Management Structure and Safety Issues Related to the

Neely Nuclear Research Reactor and the

Radiation Safety Program at Georgia Tech

Report Prepared by

Proposed Administrative Structure

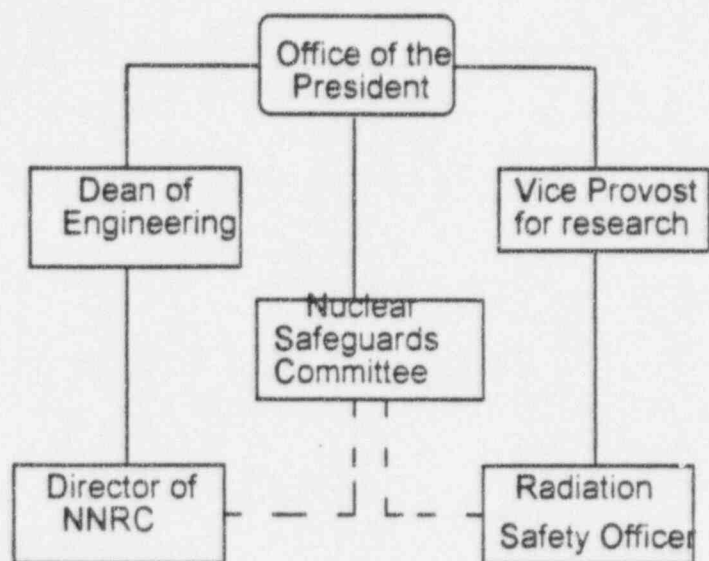
5. The present administrative structure of the Radiation Safety Program seems to work fine and there is no evidence of any kind that safety is compromised. Thus, there is no need to replace the current Director. However, the present reporting method has the potential for errors, omissions, and abuse, particularly if the current Director is replaced and the new one is not so safety-conscious.

To be specific, at present the NNRC Director is also the RSO for the campus. Everybody else reports to him, including the MORS. The Director controls the agenda of the NSC; the director controls all budgets, including that of Health Physics activities. There is no evidence that the current Director either made mistakes or abused the system. However, whenever a program or activity is controlled by a single person the possibility of error or omission of action is possible. For this reason I recommend that the institution change the administrative structure in the following way (see also diagram).

The NNRC Director should report to the Dean of Engineering or equivalent.

The Radiation Safety Officer (or MORS) should report to the Vice Provost for research or equivalent. It is important that the NNRC Director and RSO report to two different persons.

Separate budgets should be set up for the Director of the Reactor and for the RSO.

The RSO will be responsible for Health Physics coverage for the GT campus; the Director of NNRC will be responsible for the safe operation of NNRC and will get Health Physics coverage from the RSO. Both the Director and RSO,

- a. are non-voting members of the NSC; they should be allowed to send their designated representative to a meeting if they themselves cannot be present,
 - b. report to the NSC and both contribute to the agenda of the NSC meetings,
 - c. in case of differences of opinion between the Director and RSO, differences that are not covered by existing operating procedures, the NSC will resolve the issue.
6. The present structure and method of appointment of the NSC membership are excellent and should continue.

Diagram used in the calculation of the dose rate from the ^{60}Co source. Dose rate was obtained for point A.

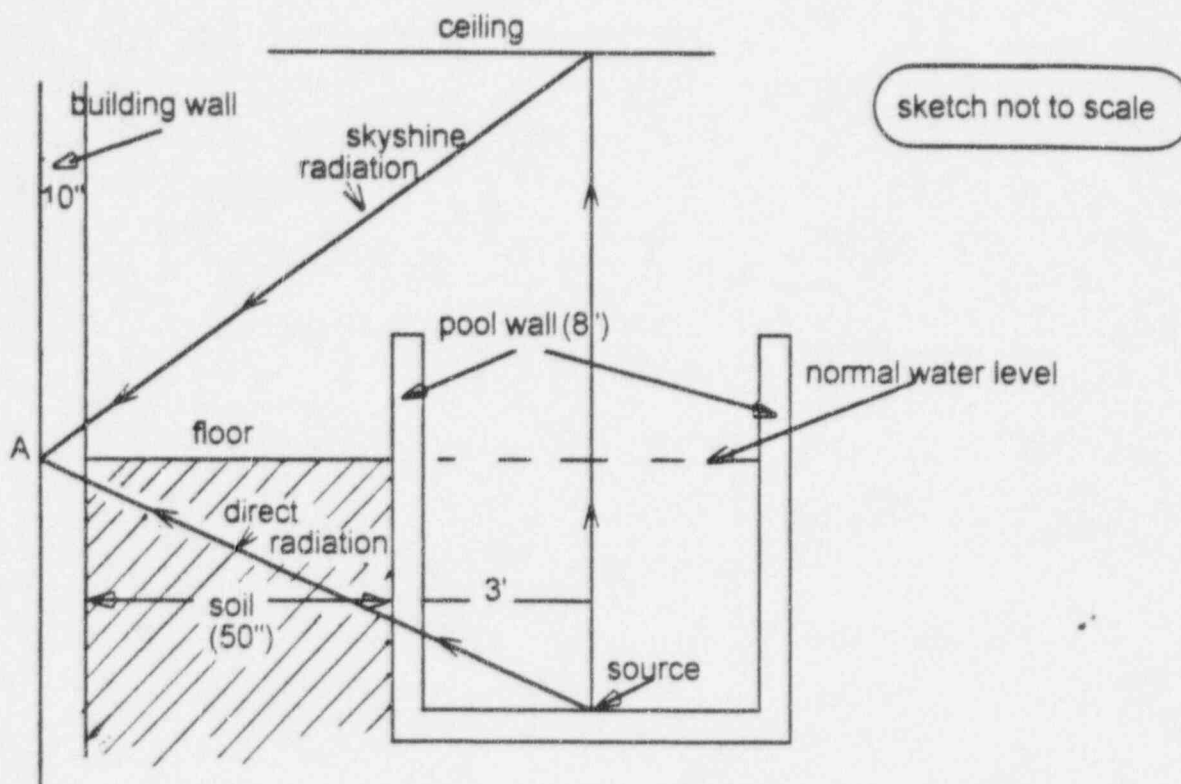
I performed a calculation, using very conservative assumptions, of the dose rate at the outside of the wall of the building, at a point where the highest dose rate would be expected (point A, see sketch). With the water gone, radiation shielding is provided by the wall of the pool, the soil between the pool and the wall, and the building wall itself. I made the following assumptions.

- (i) The source is located at the center at the bottom of the pool.
- (ii) I neglected any self-absorption in the source and attenuation by the air.
- (iii) I assumed all the shielding material to be soil (dirt) with density 1.5 g/cm^3 , i.e. I considered the concrete walls to have that density as well (true concrete density is at least 2.35 g/cm^3).
- (iv) I considered the gamma-ray buildup (from scattering of gammas in the attenuating medium).
- (v) I considered 'skyshine' radiation, i.e. gammas that hit the ceiling of the building and are scattered back towards the point of interest. I made the very conservative assumption that 3% of the gammas hitting the ceiling are reflected back towards the outside wall.

Direct dose rate is about $3 \times 10^{-8} \text{ mrem/h}$

Dose rate from skyshine is about $6 \times 10^{-5} \text{ mrem/h}$

It should be mentioned that the background radiation level should be about 0.01 to 0.03 mrem/h (excluding radon). Thus, even under the most conservative assumptions, with the loss of water in the pool, a person could standing close to the outside wall would receive less than 1% of the background radiation that exists everywhere and is received by every person anywhere.

Based on this calculation, I do not consider it necessary to have the already existing fence around the NNRC replaced or reinforced ; a new fence would just attract attention and raise questions without increasing safety.
